C O N V A I R.
A Division of General Dynamics Corporation
San Diego, California

COMMERCIAL CHANGE PROPOSAL

SPEC NO: ZD-22-003 DATE: _____
CUSTOMER: Delta Air Lines Inc. MCL 10,158 Dtd _____
CHANGE NO: 100 MODEL: (880) 22-2

TITLE: **Tinted Interior Cabin Windows, Installation of**

Enclosure to CCP No. 99A

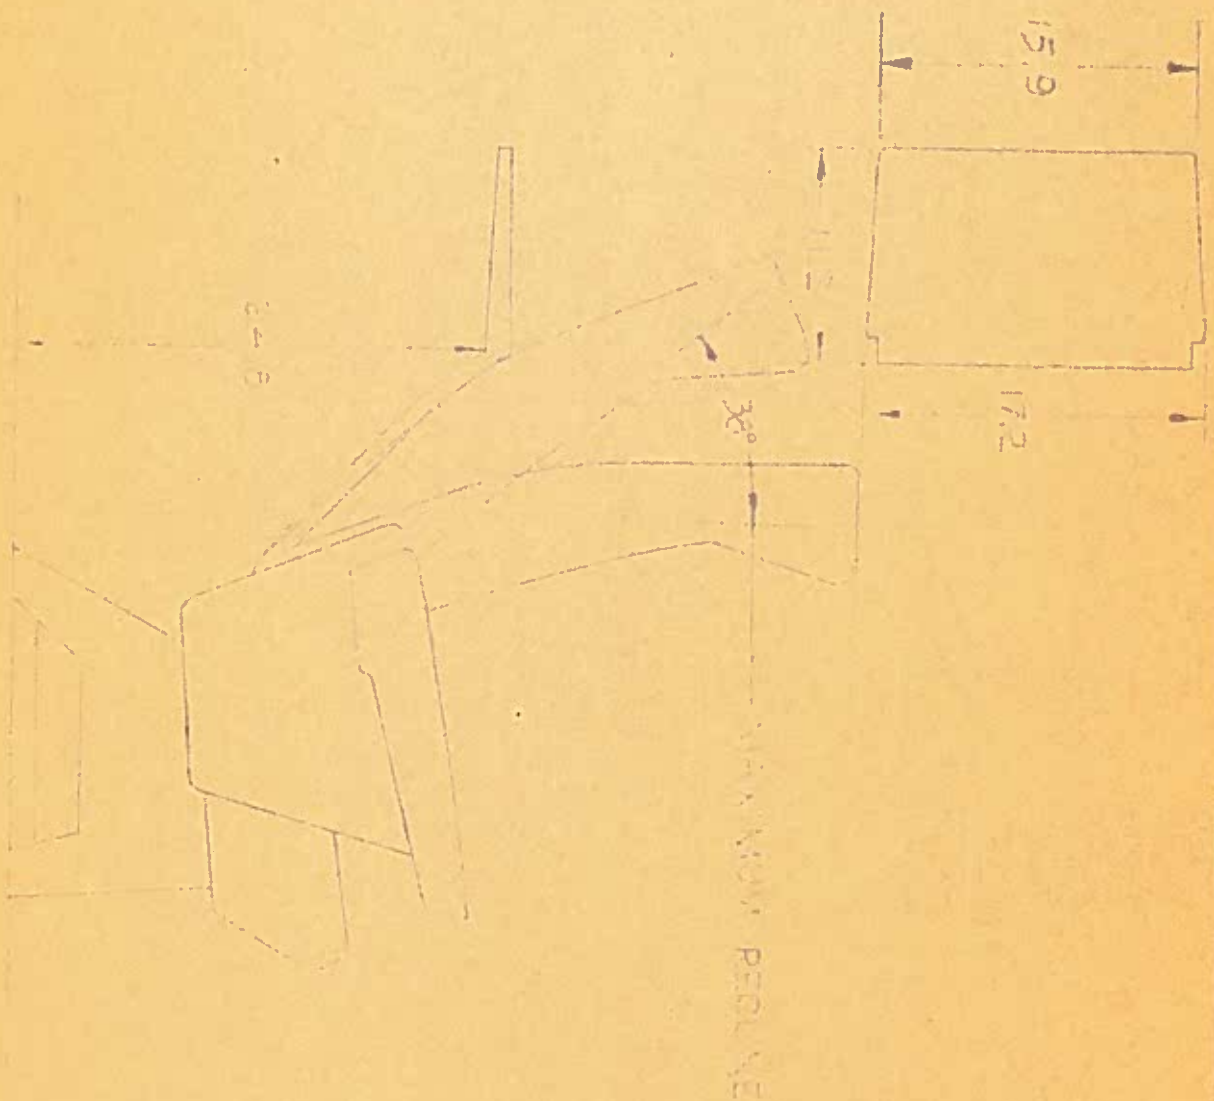
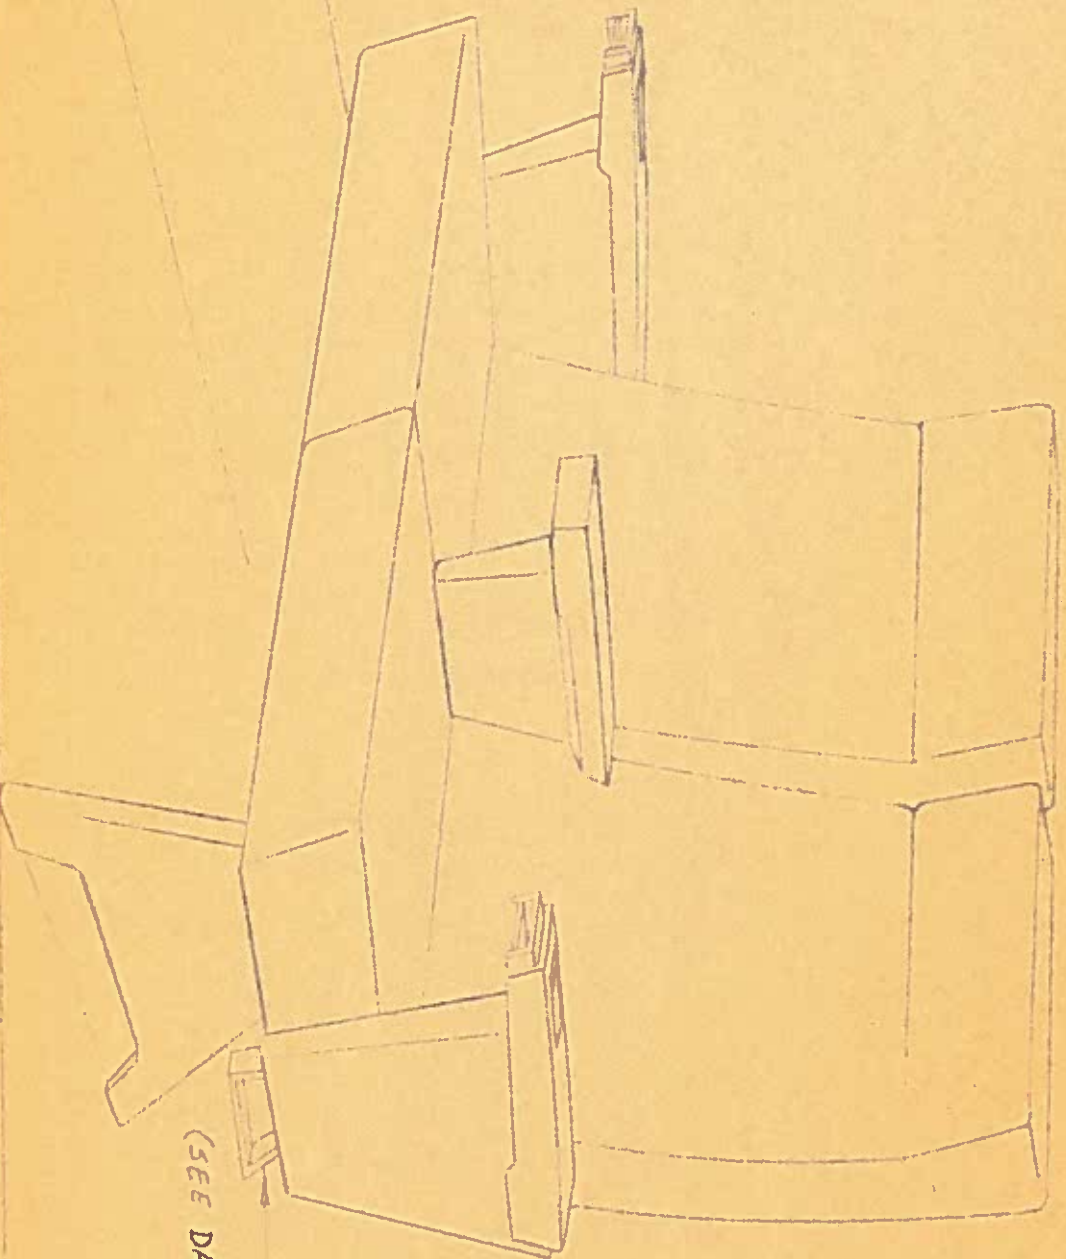
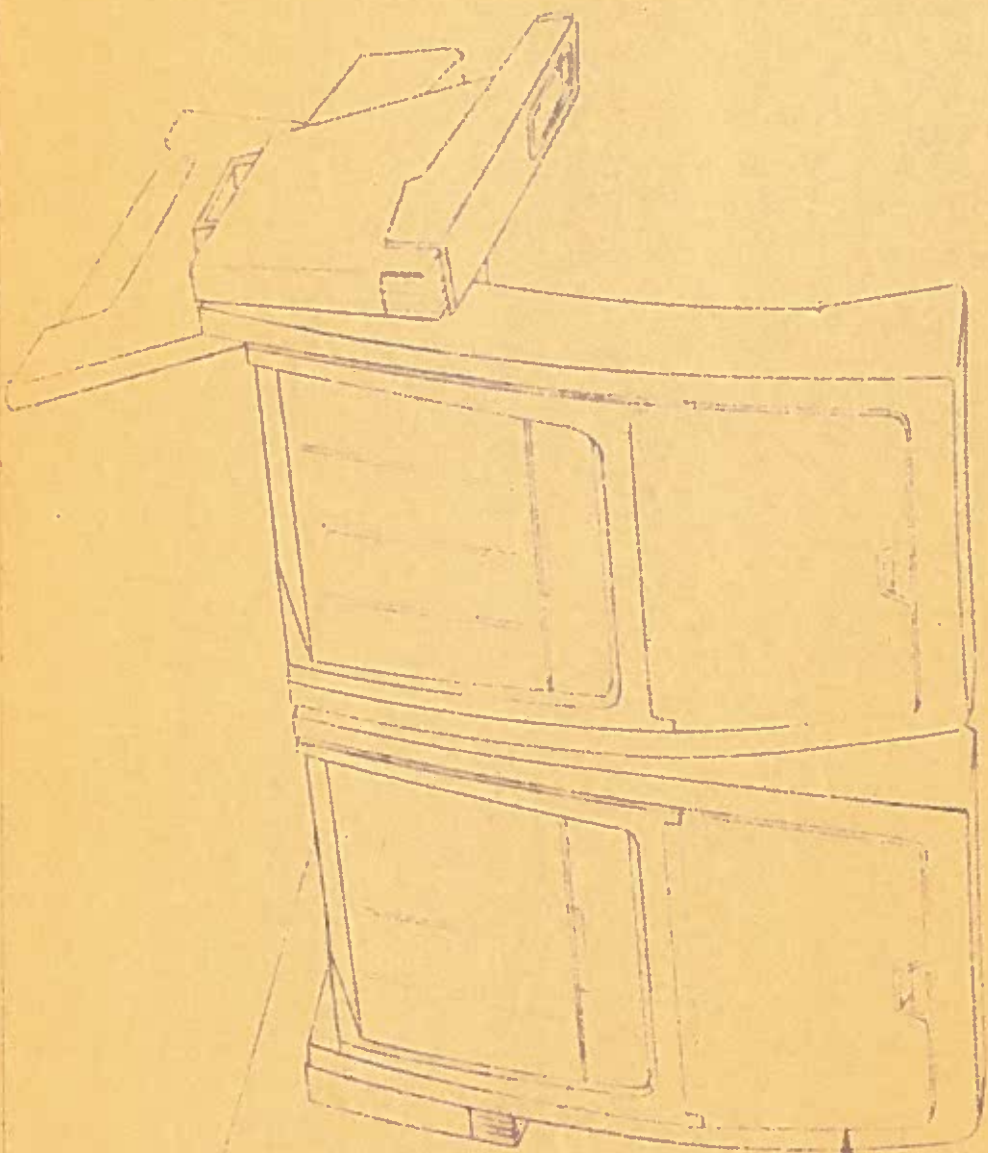
Reason for Change: To provide a seat in accordance with Customer comments.

Figure 1-2, INBOARD PROFILE AND PLAN VIEW:

Revise figure to show the following seat width and spacing:

Figure 1-3, ALTERNATE SEATING ARRANGEMENT:

Revise Standard Section of "Mixed Seating Arrangement" of figure in same manner as Figure 1-2.

MODEL 22 HIGH PRESS. OXYGEN GAS SYSTEM SCHEMATIC (FIG 3.19-4)

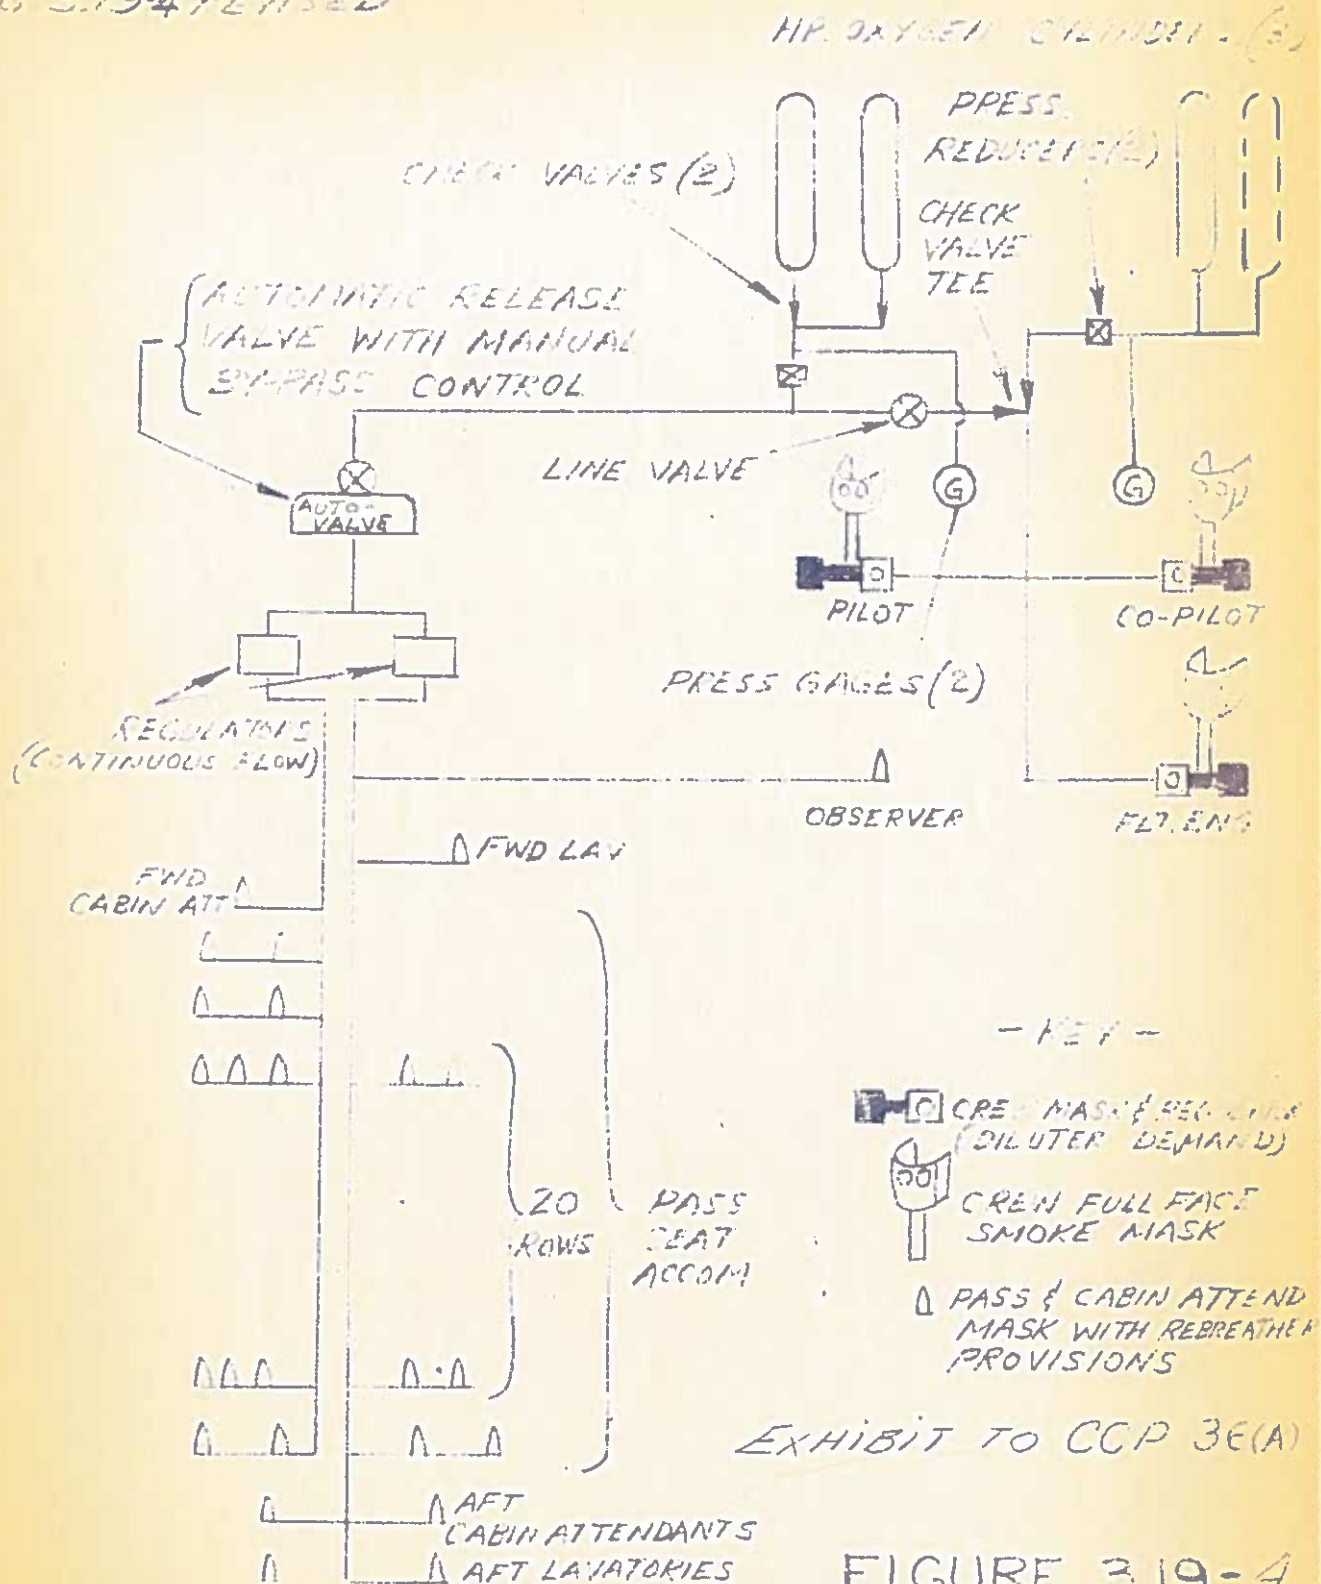
Figure 3.19-4 dtd 7-26-56

FIGURE 3.19-GA

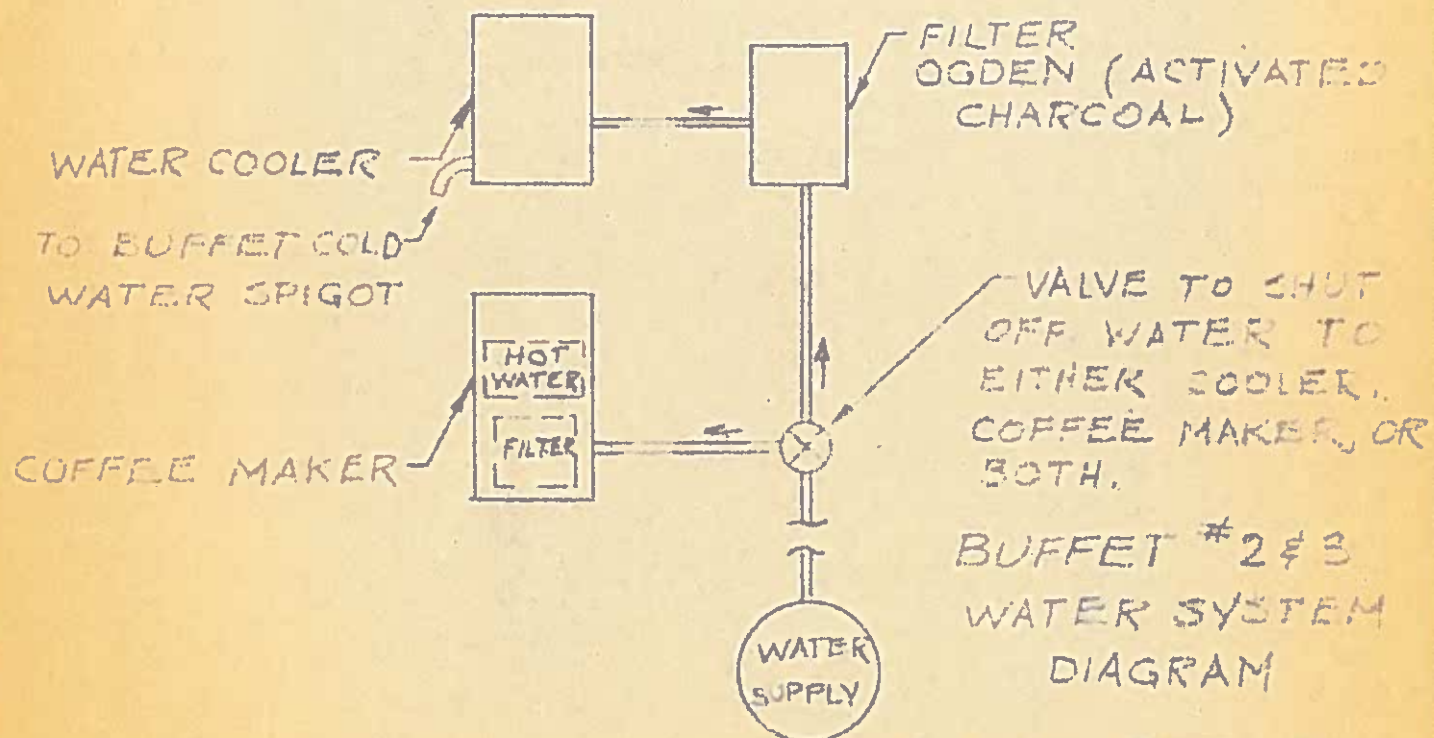
Enclosures: (A) Four (4) copies Figure 3.19-5 Revision C
(B) Four (4) copies Figure 3.19-6 Revision C
(C) Four (4) copies Figure 3.19-6A Revision A
(D) Four (4) copies Figure 3.19-7 Revision A, Alt. B

12-PLACE CLUB AREA

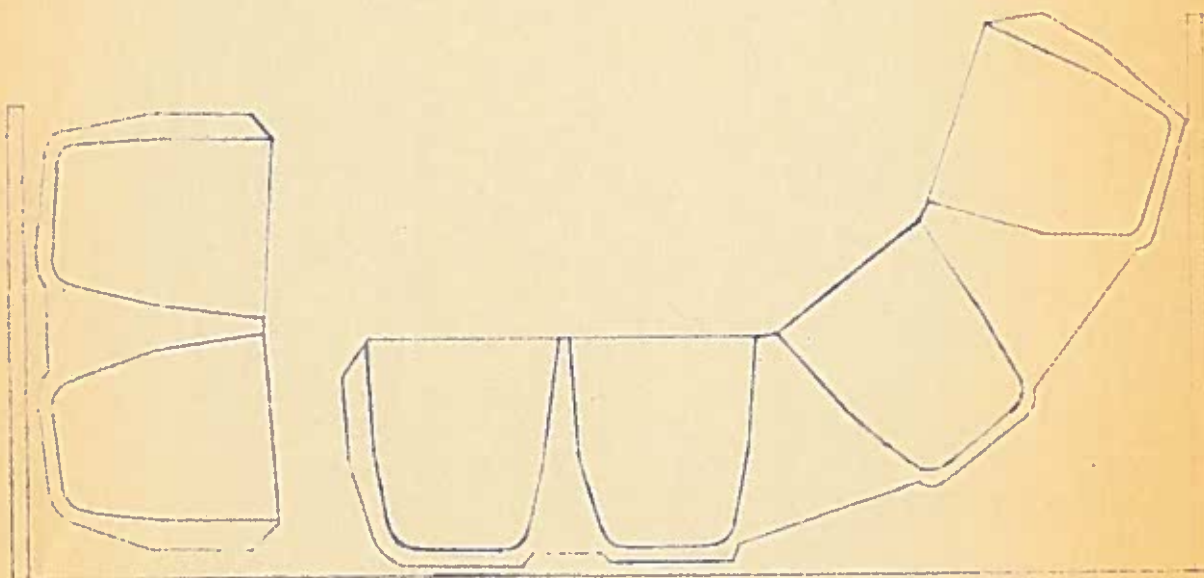
Sixth item, "Lounge Seats (Double)" change: "2 Lounge Seats (Double)" to "4 Club Area Seats (Double)"

Figure 1-2 - INBOARD PROFILE AND PLAN VIEW
Figure 1-3 - ALTERNATE SEATING ARRANGEMENT
Figure 3.7-1 - EMERGENCY EXIT FLOW
Figure 3.19-4 - HIGH PRESSURE OXYGEN GAS SYSTEM SCHEMATIC

Revise above figures as required to reflect change.

Enclosure: (A) One (1) copy of sketch of proposed Club Area Arrangement.

FIGURE 1-1
GENERAL ARRANGEMENT
MODEL 22 JET TRANSPORT

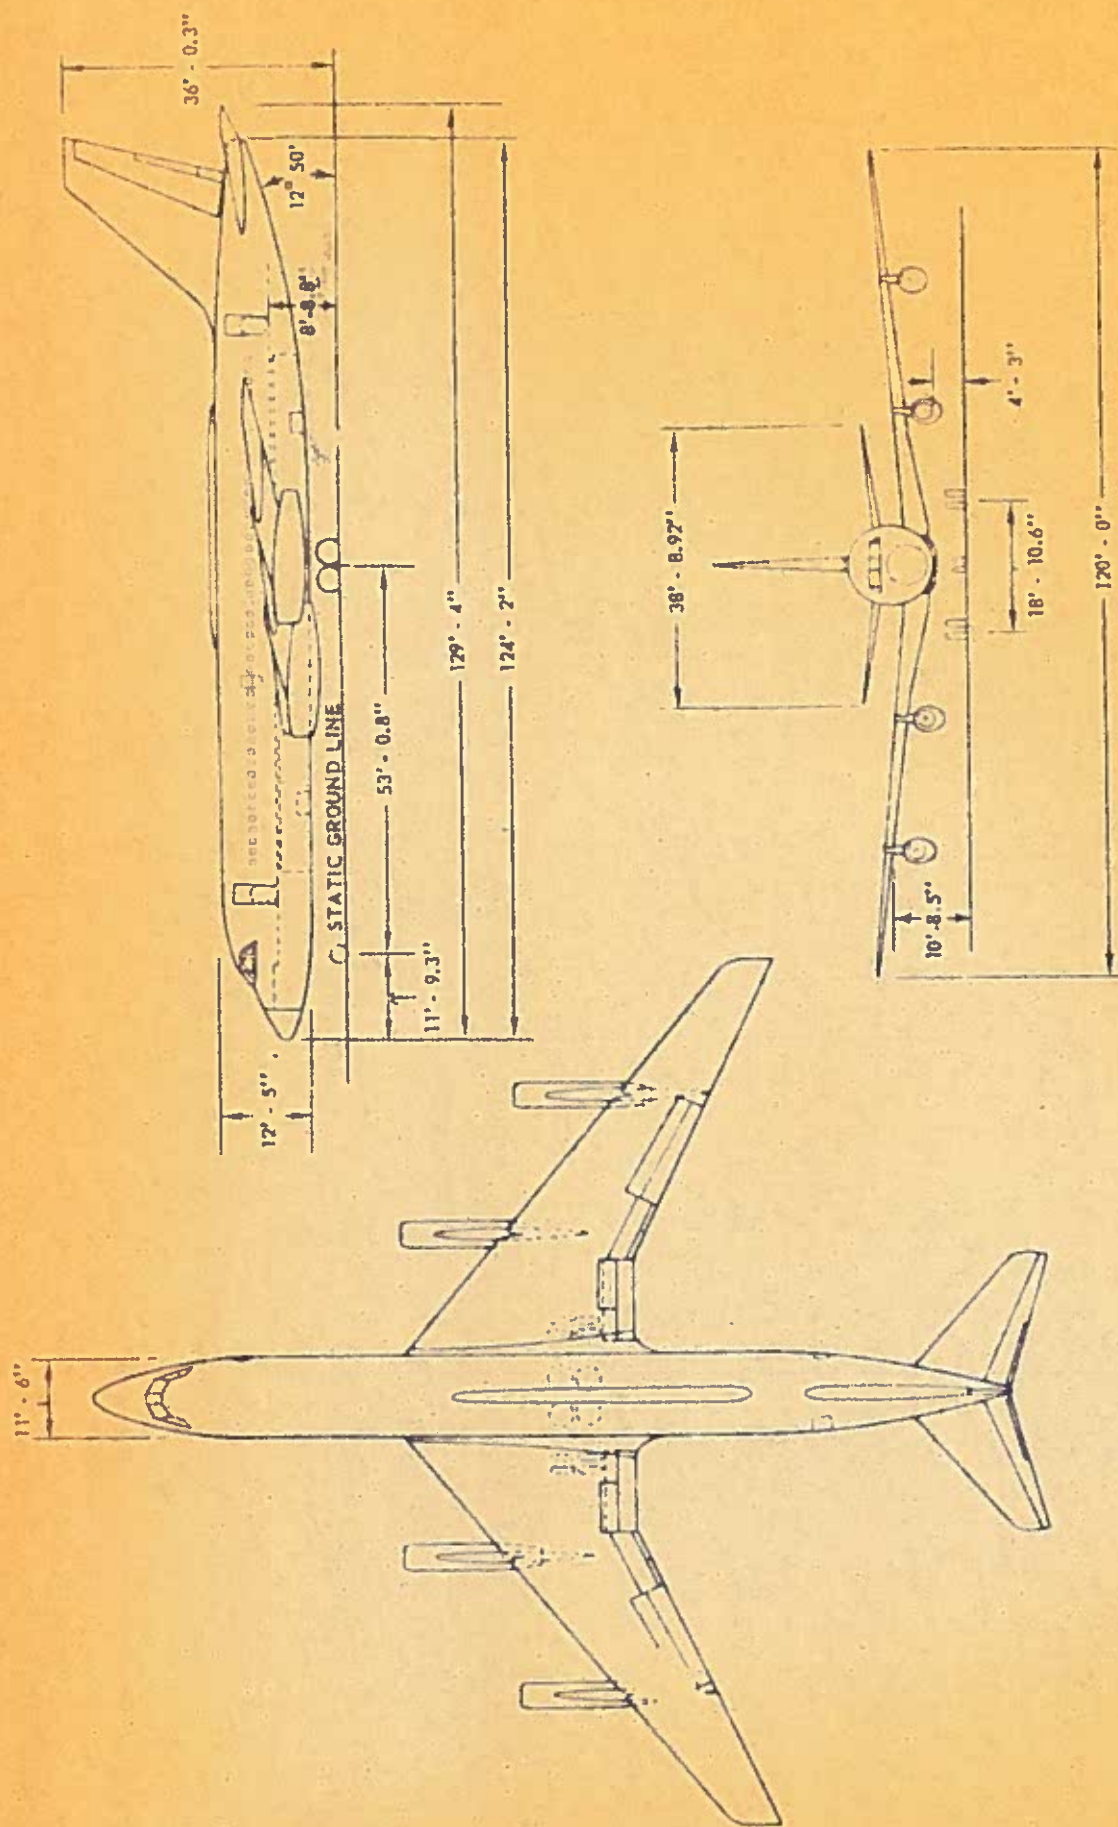
Figure 1-1 GENERAL ARRANGEMENT, MODEL 22 JET TRANSPORT

Enclosure: (A) Four (4) copies Figure 1-1, GENERAL ARRANGEMENT OF MODEL 22 JET TRANSPORT
